Peach Bottom Atomic Power Station, Units 2 and 3
Facility Operating License Nos. DPR-44 and DPR-56
NRC Docket Nos. 50-277 and 50-278

Subject: Extended Power Uprate License Amendment Request – Supplement 7
Response to Request for Additional Information - Extended Power Uprate

Response to Request for Additional Information – SCVB

Figure 6-1 - PBAPS EPU DW Temperature Response

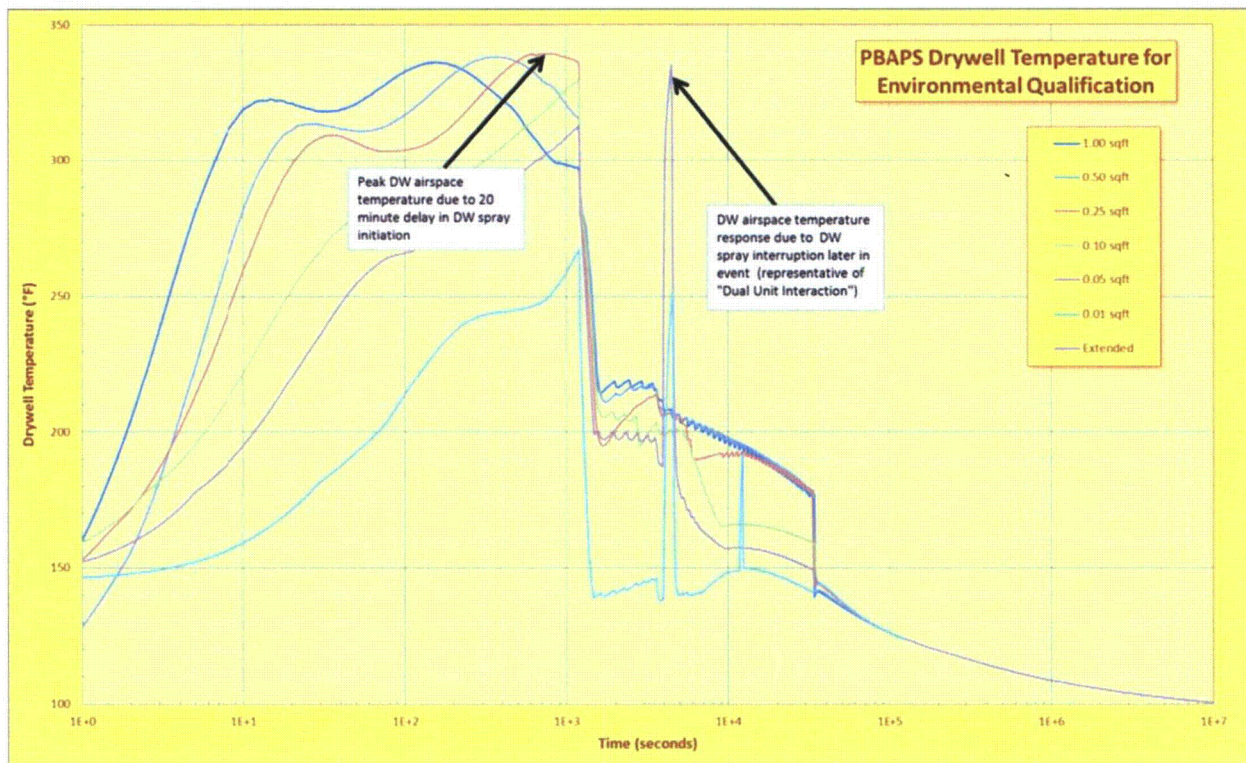
As discussed in PUSAR Section 2.6.3.1.1, the calculated peak drywell wall temperature of 281 °F is the same as the design temperature. Please explain the method of calculating the wall temperature based on the peak drywell gas temperature of 340 °F, including the assumptions used for conservative results. What is the limiting drywell wall temperature obtained from dual unit interaction analysis? In case it has the same value (i.e., 281 °F) as obtained from the single unit analysis, please justify why it is the same.

Predicted peak drywell (DW) shell temperatures reported in PUSAR Section 2.6.3.1.1 (Reference 6-1) are obtained from steam line break analysis with the [[

]] This results

in the peak DW wall temperature of 281°F for both the single unit and dual unit interaction analyses.

The maximum predicted DW shell temperatures occur at the beginning of the event prior to the initiation of DW sprays. This is because the maximum DW atmosphere temperature and DW pressure conditions occur during this early period with maximum heat transfer to the DW shell. Postulated interruptions which may occur in DW spray operation due to "dual unit interaction" would produce temporary increases in DW atmosphere temperature and pressure and consequently DW shell temperature. However, these interruptions attributed to "dual unit interaction" occur later in the event,

when the non-accident unit has depressurized below the 450 psig reactor pressure vessel (RPV) pressure required for the generation of a LOCA signal from the non-accident unit.

Figure 6-1 below illustrates the impact of multiple containment cooling (DW spray) interruptions on the accident unit DW temperature response. Note that Figure 6-1 is an annotated copy of PUSAR Figure 2.6-10. While Figure 6-1 is for the DW airspace temperature, the DW shell temperature response will follow the same trend as illustrated in Figure 6-1.

The maximum DW airspace and DW shell temperature occurs early in the event with the assumption that a High DW pressure/Low RPV pressure LOCA signal occurs in the accident unit 10 minutes after the accident initiation. This LOCA signal at 10-minutes will result in a further 10 minute delay in the initiation of DW spray in the accident unit (20 minute total delay for DW spray initiation). A subsequent interruption of DW spray on the accident unit due to "dual unit interaction" occurs much later in the event when the accident unit has depressurized, which results in a lower energy release and subsequent lower reheat of the DW atmosphere and DW shell.
